737

Service Bulletin

Number: 737-28A1206
Original Issue: January 11, 2006
Revision 2: May 21, 2009
ATA System: 2822 3152

SUBJECT: FUEL - Distribution - Center Fuel Tank Boost Pump Auto Shutoff and Master Caution Logic Change

FIGURE 39: W0044 WIRE BUNDLE ROUTING

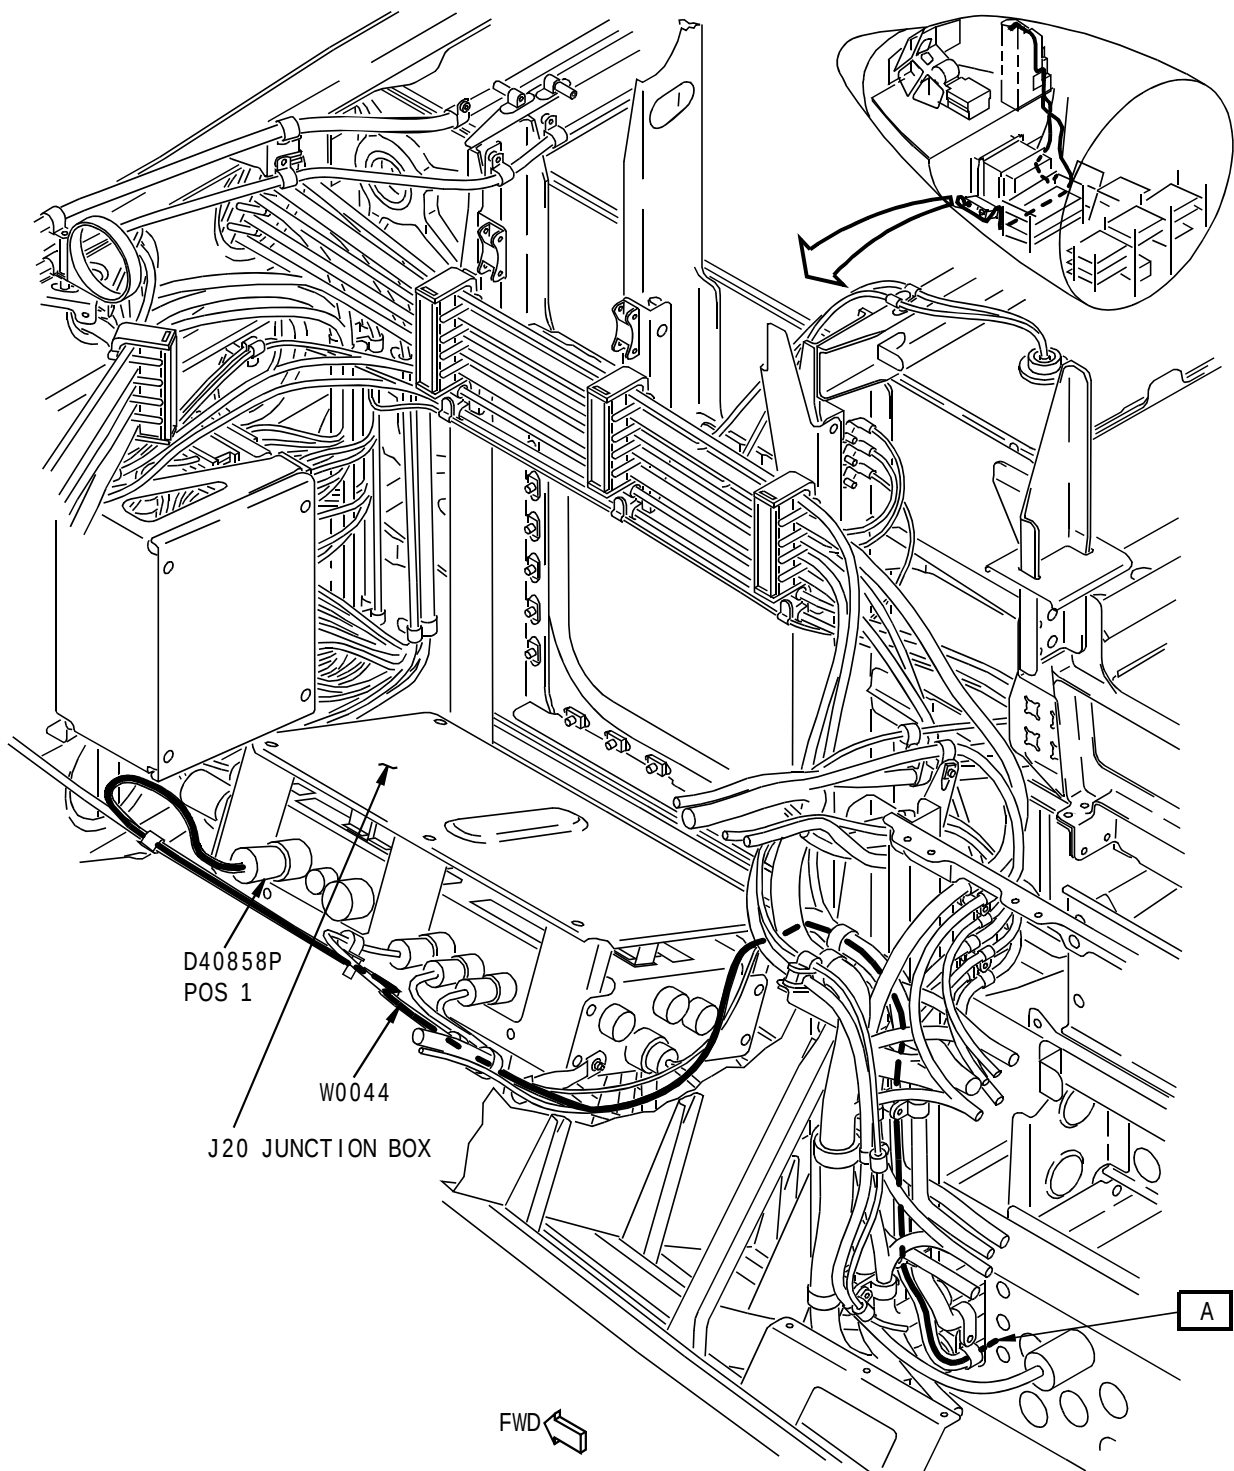
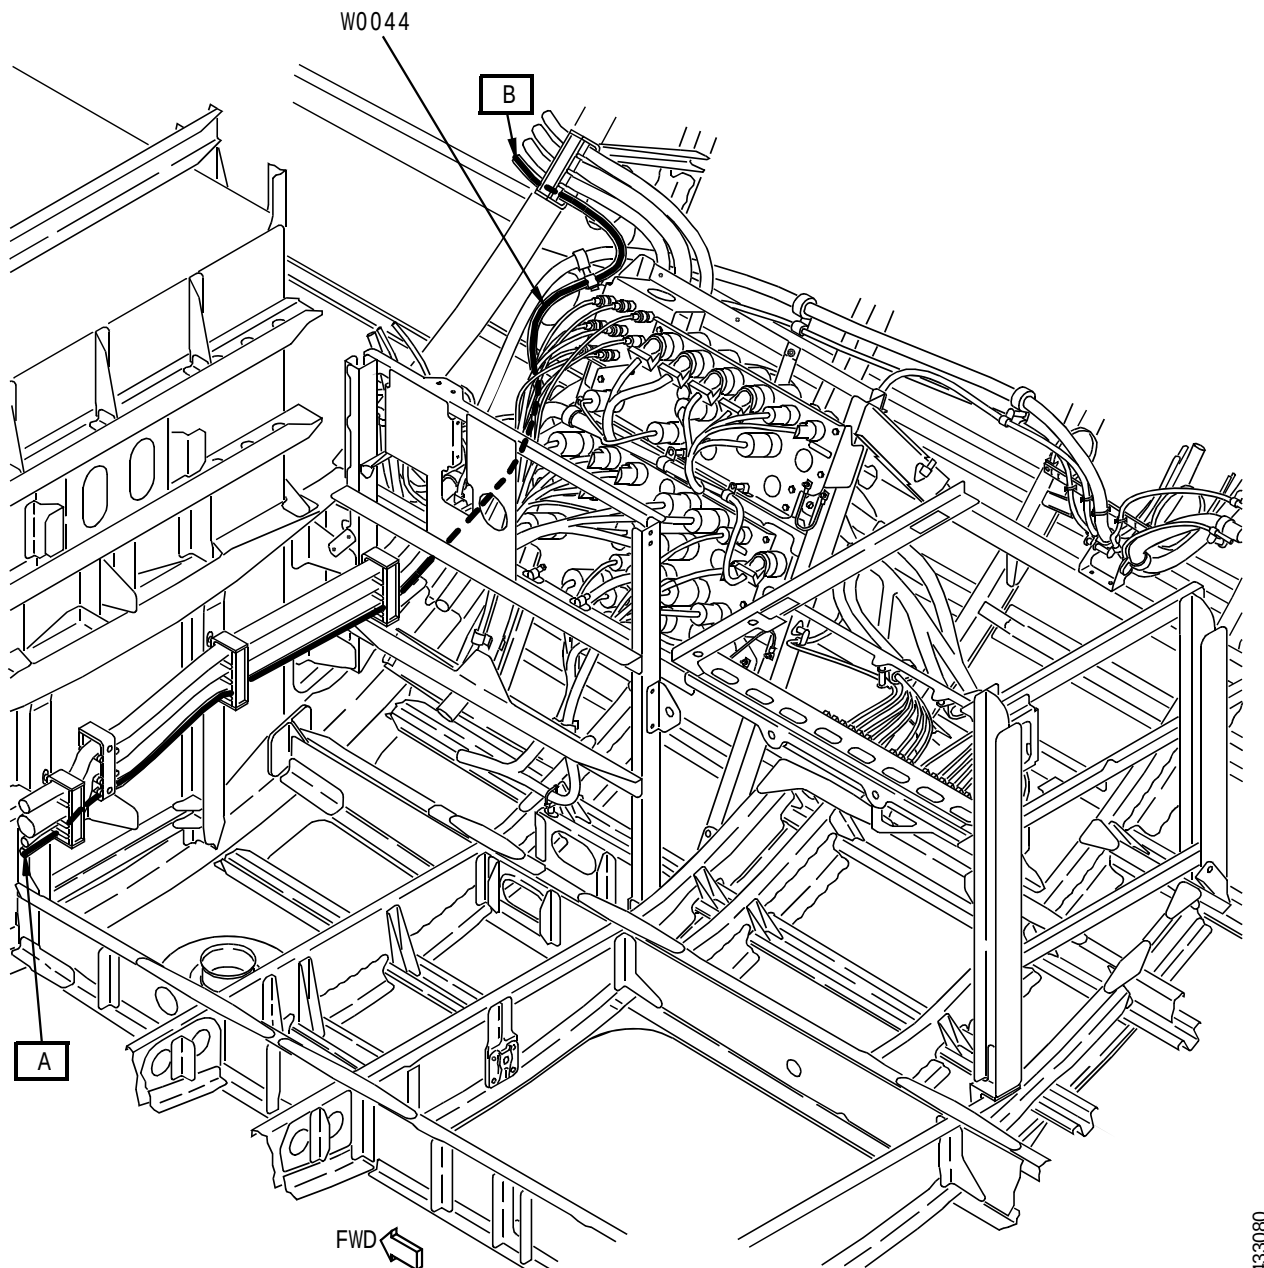
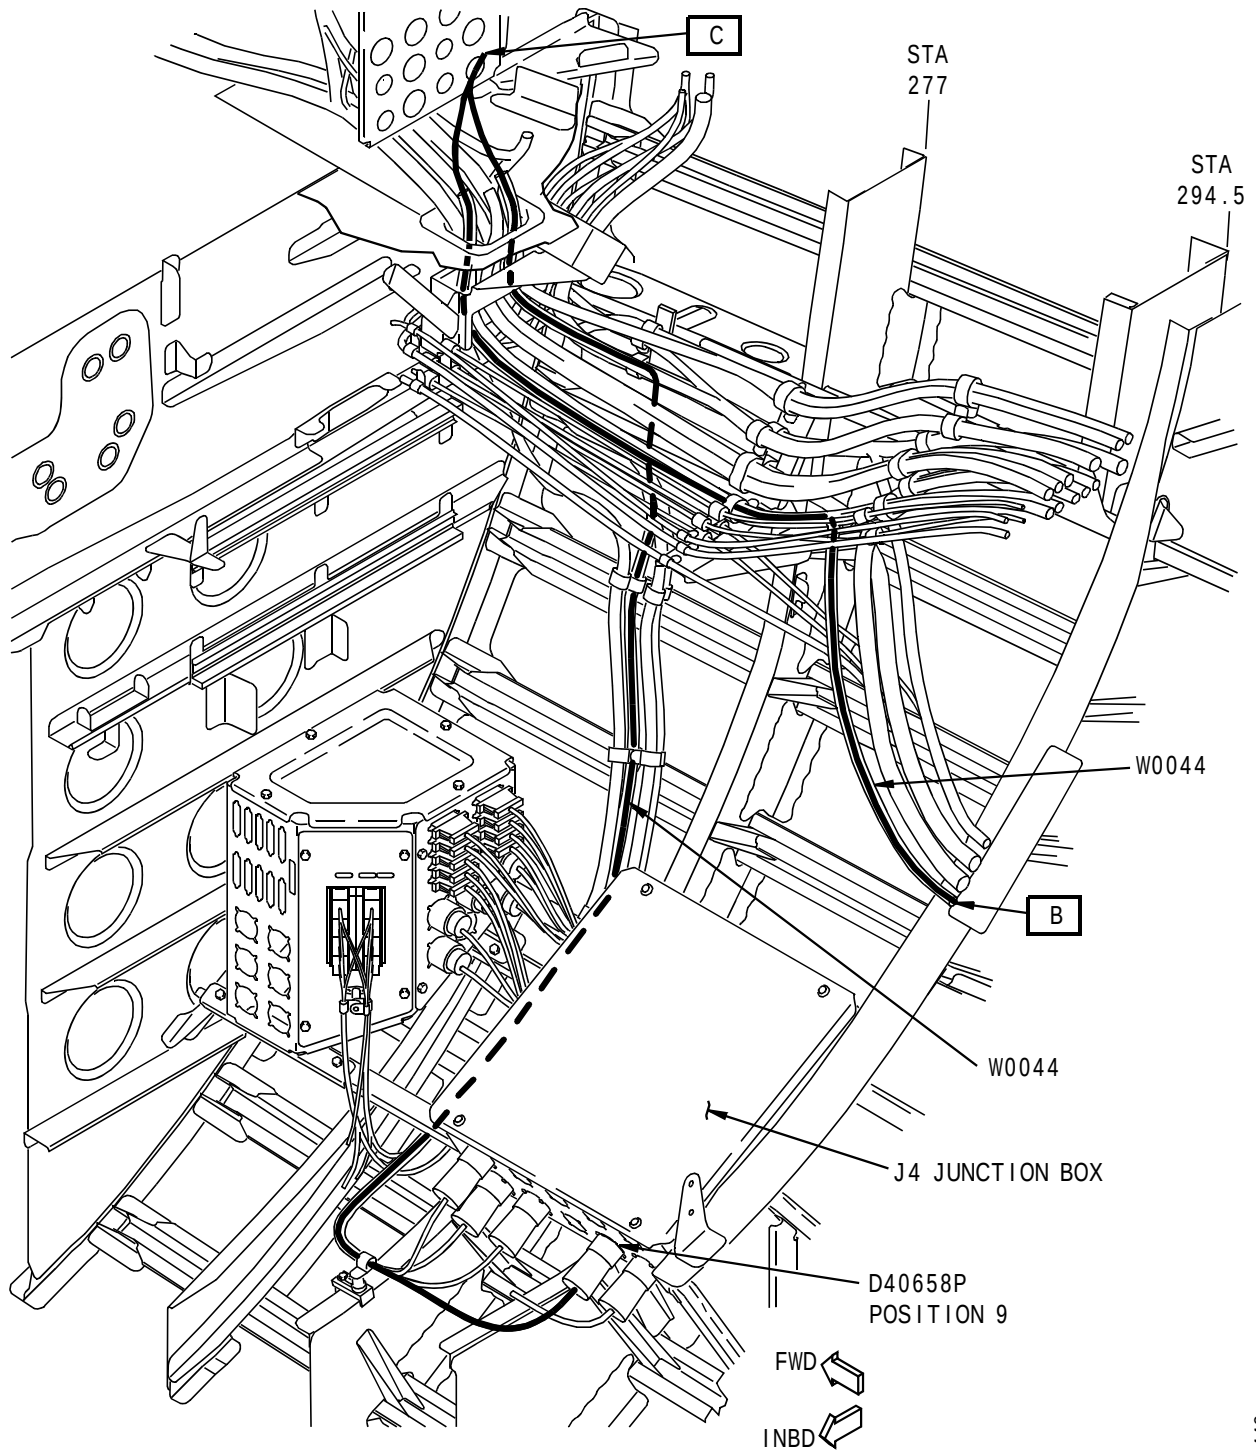
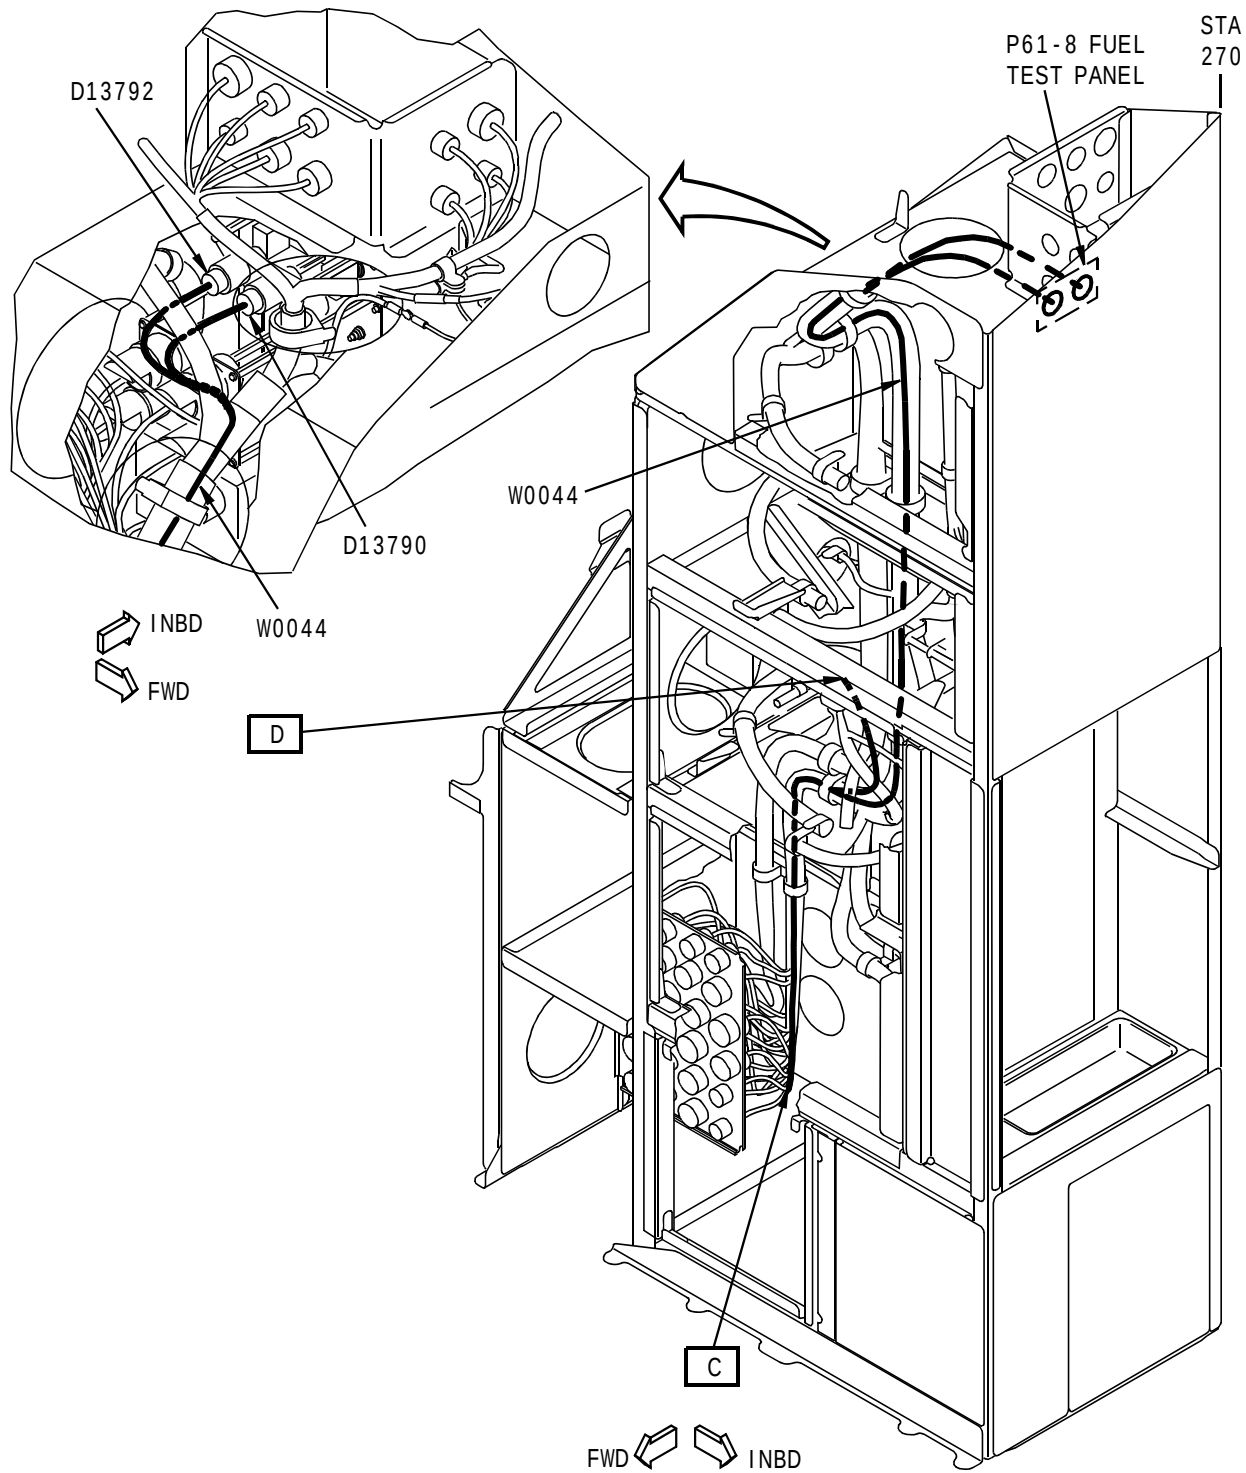
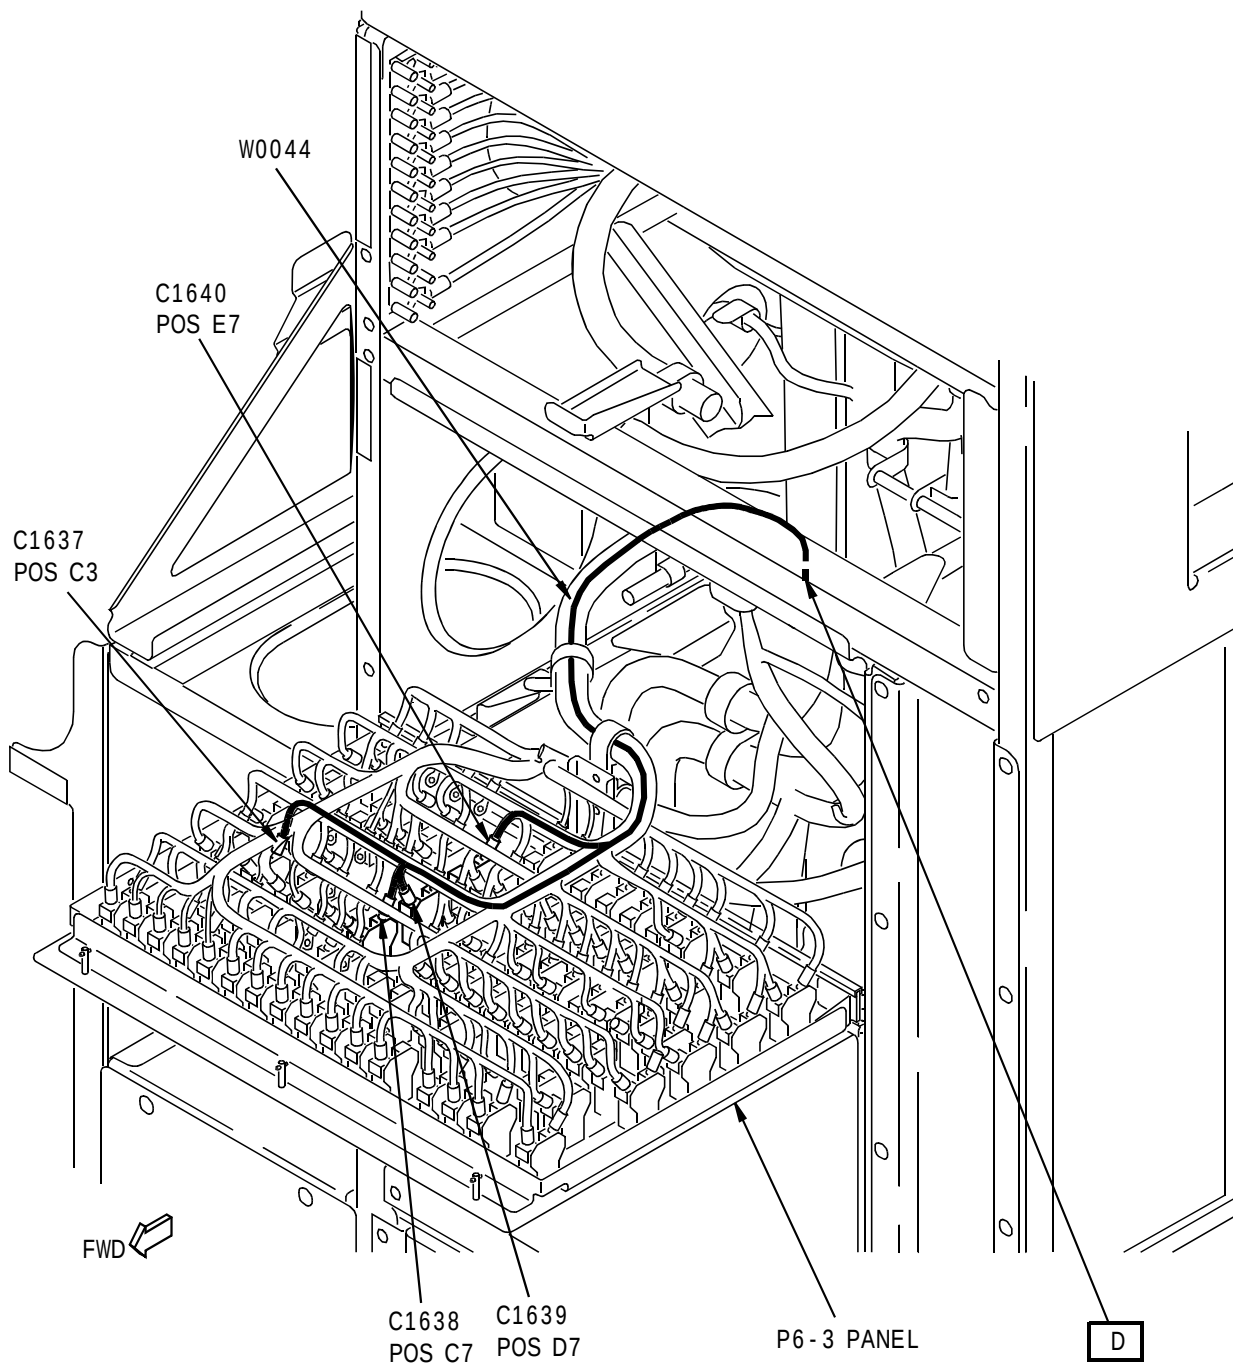
Changes are made to Figure 39 to show the route of wire bundle W0044 to the P6-3 circuit breaker panel. The Figure effectivity is changed to remove the Group 12 airplanes.
